Reduce the existing building area to include a two tenant space and remove 1 parking space.

Re: Agent Authorization Notice – 2100 Louisiana Blvd. NE (Winrock Town Center)

RE: 1002202 - WINROCK TOWN CENTER - BLVD. NE – ALBUQUERQUE, NM 87110 – ADMINISTRATIVE AMENDMENT TO EXISTING PAD SITE AND ELEVATIONS

AMENDED PLANS

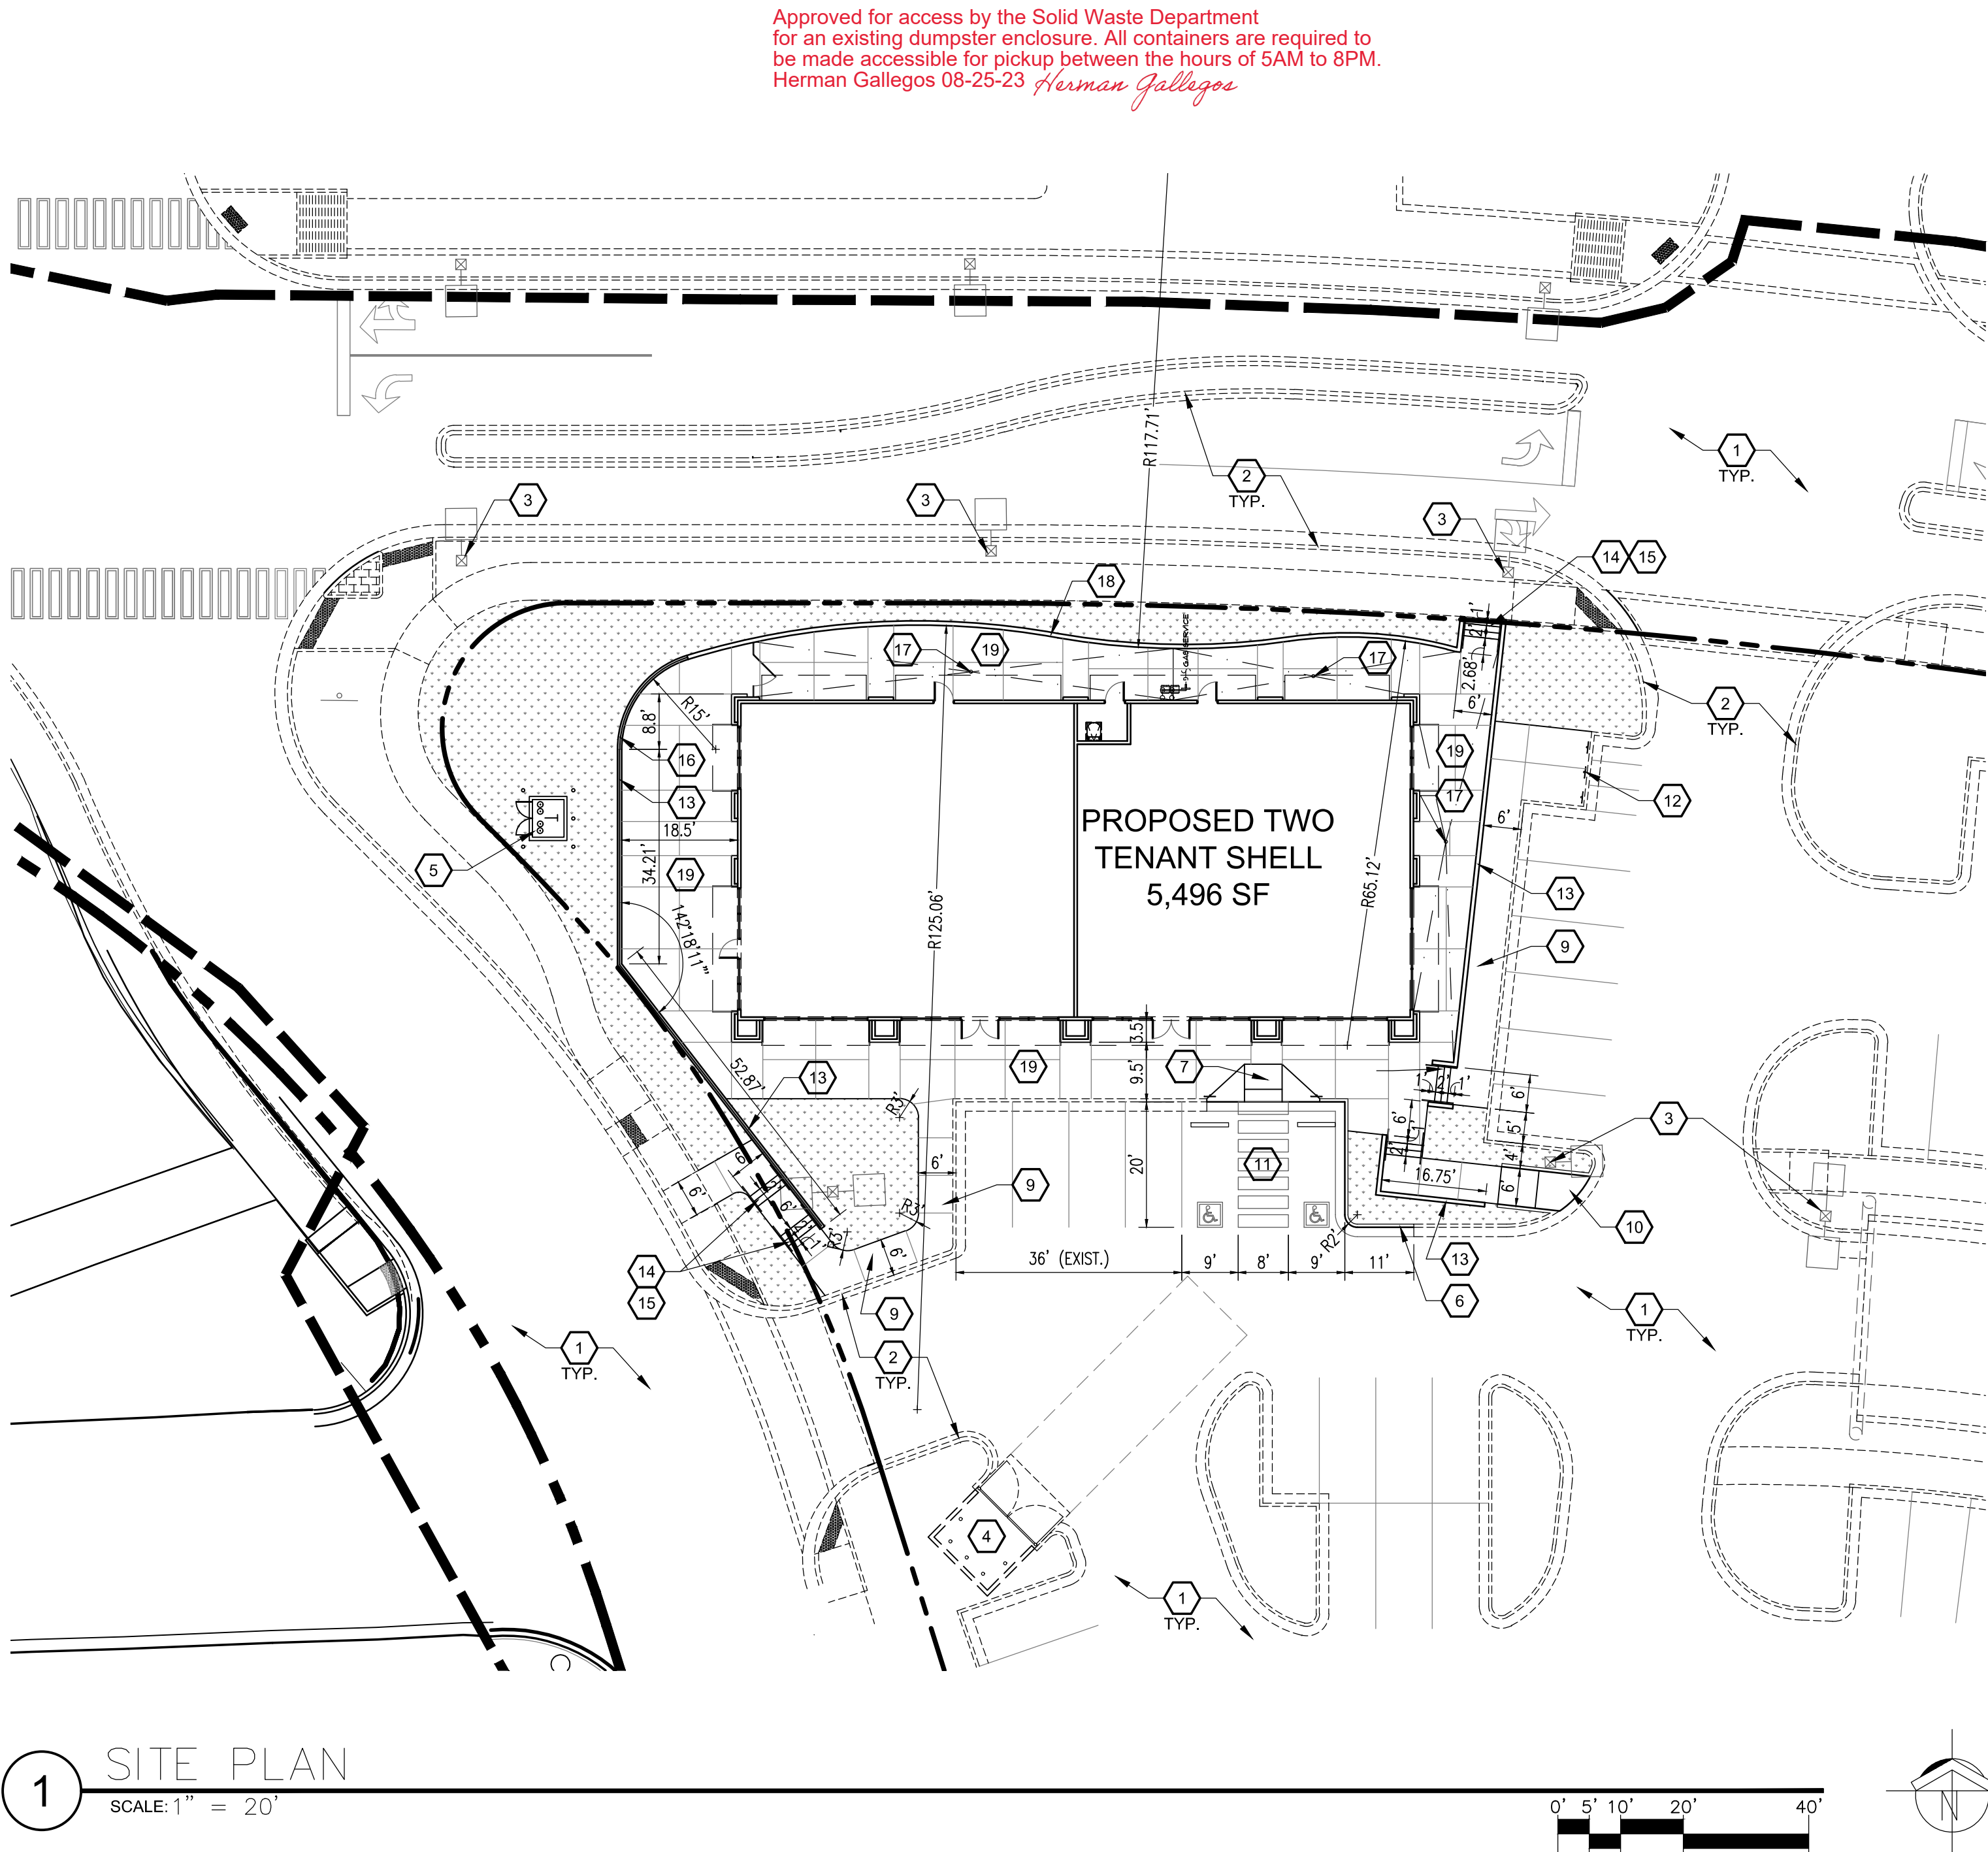
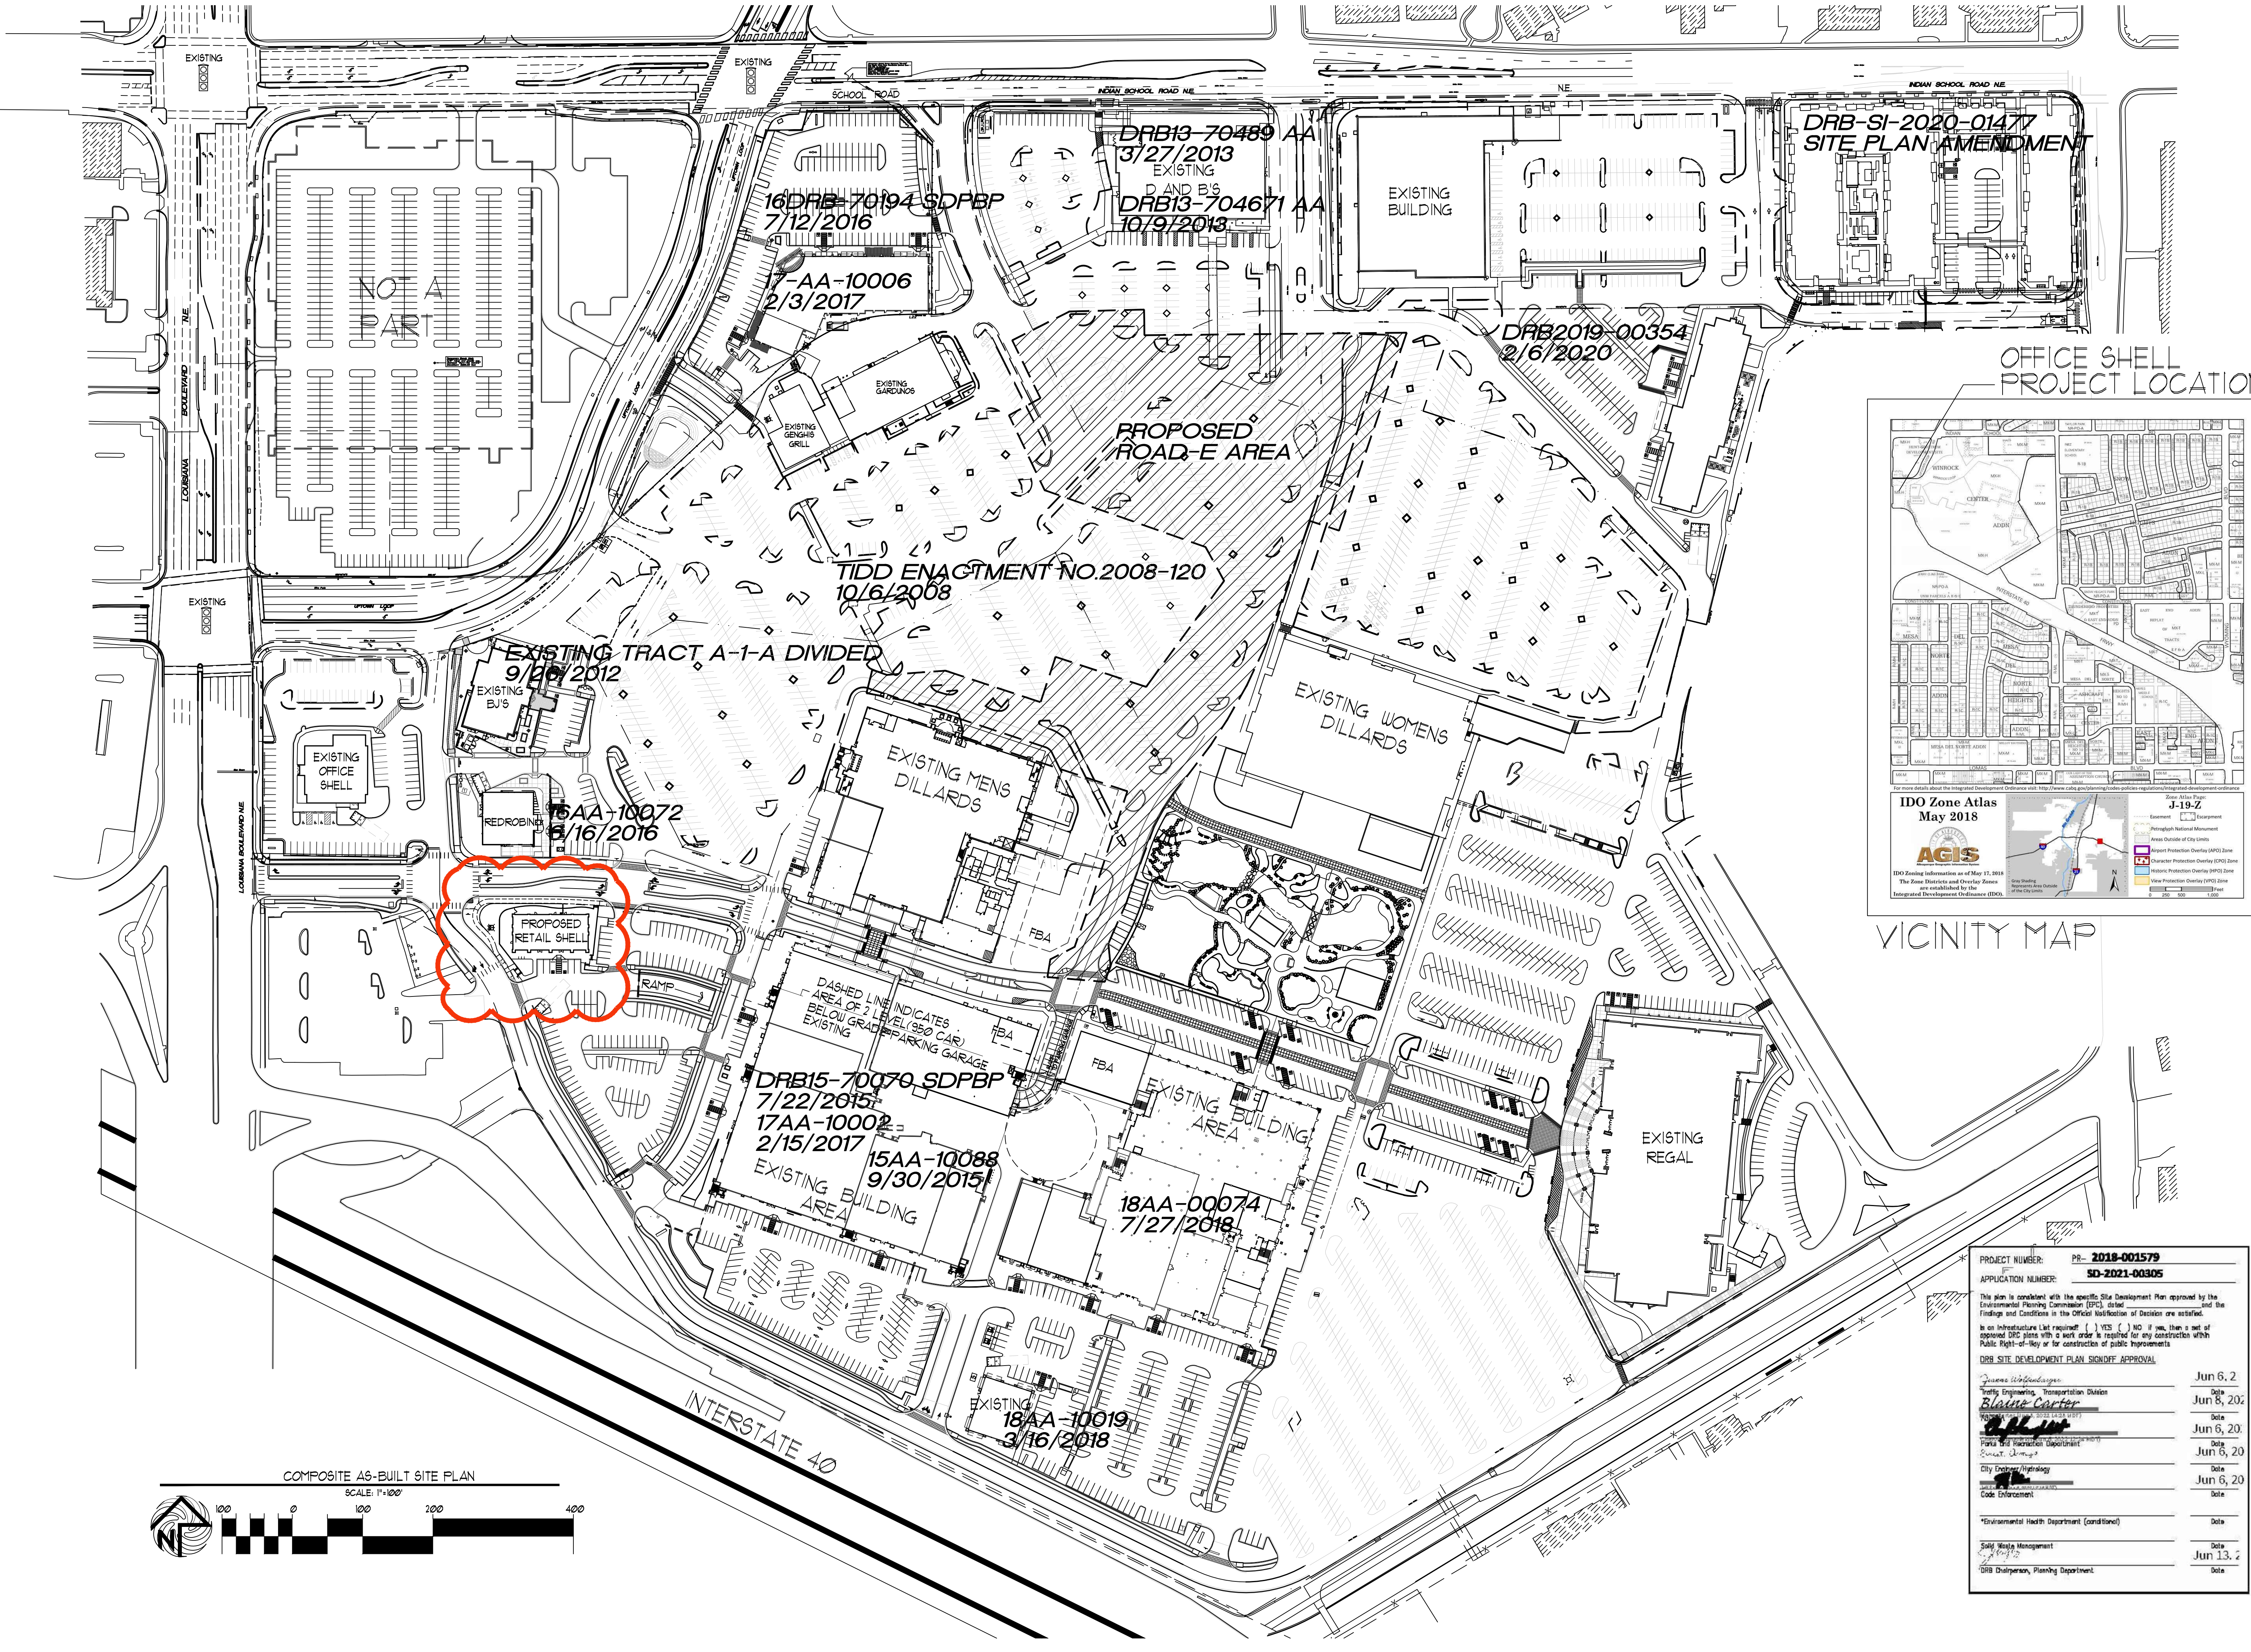
- The new configuration has been updated to accommodate the minor changes.
